CEC-g1 [rev-6]
Page 1 of 4

CANADIAN ELECTRICAL CODE

SUBJECT: Errata

Figure 7
Three-phase, 3-wire ungrounded (delta) system

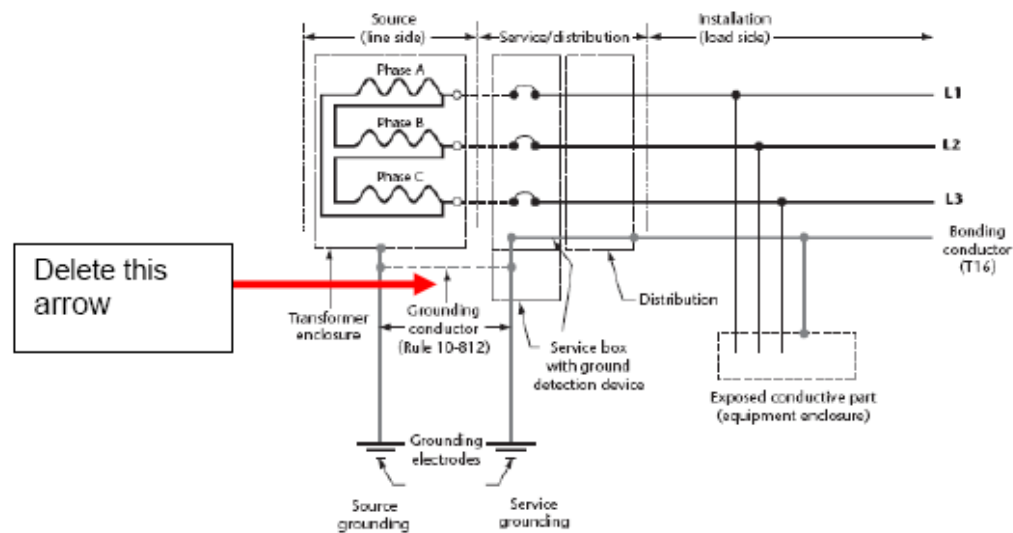
Appendix B note for Rule 10-812 – Delete one arrow in Figure 7:
